## TECHNICAL SERVICE BULLETIN

**Technical Service Bulletin Number-TSB0015 – Shift-N-Step Shortened Rack**

**Item, Unit or Assembly Affected – Shift-N-Step (Drive Ski)**

**Unit(s) Affected – SNS5770356—SNS5770481**

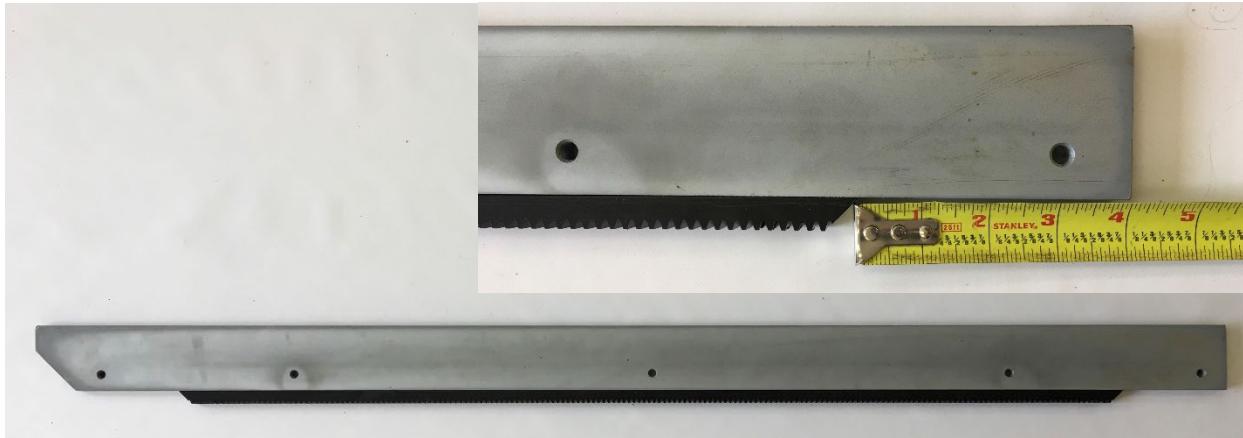
**Reason for Bulletin –** Affected Shift-N-Step units will look and operate normally, but have a shortened range of teeth on the rack of the drive ski. To determine if this affects your unit, operate the Shift-N-Step to put the lift in the full right (lift operation) position. Then, look into the channel where the emergency back-up/manual operation tool is inserted and determine if the rack teeth extend far enough to the left for the tool to work properly. Replacement skis may be ordered free of charge directly from [mary@abilitrax.com](mailto:mary@abilitrax.com). Labor reimbursement claims are be made by contacting [ap@fentonmobility.com](mailto:ap@fentonmobility.com). Labor allowance will be at a rate of 3 hrs @ \$90.00 per hour

The drive ski must be **replaced**.

## Bolt Length Requirements for Mounting Braun or Ricon Lift to Shift-N-Step

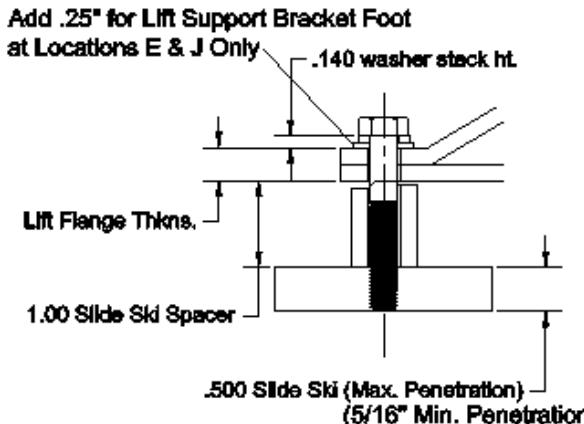
Using the proper length bolts to attach a Braun or Ricon Lift to the Shift-N-Step Unit is critical. Required bolt lengths will vary depending on Lift Manufacturer and Bolt location. Using Bolts that are too long may result in bolts protruding beyond the face of the Slide Skis. This will cause the Skis to "drag" in the channels and will cause the Shift-N-Step to bind or jam. Protruding bolts will also damage the Ski bearing surfaces. Bolts must also penetrate at least 5/16" into the Slide Skis to assure adequate lift retention.

.140 + Lift Flange + 1.00 + .500  
= Bolt Length\* @ A, B C, D, F, G, H, & I

.140 + .25 + Lift Flange + 1.00 + .500  
= Bolt Length\* @ E & J ONLY

\*Round Down to Nearest available  
bolt length but 5/16" MINIMUM Bolt  
penetration MUST be maintained.  
Any changes to total stacked height  
(added shims, altered Slide Ski  
Spacer height, etc.) must be  
accommodated accordingly
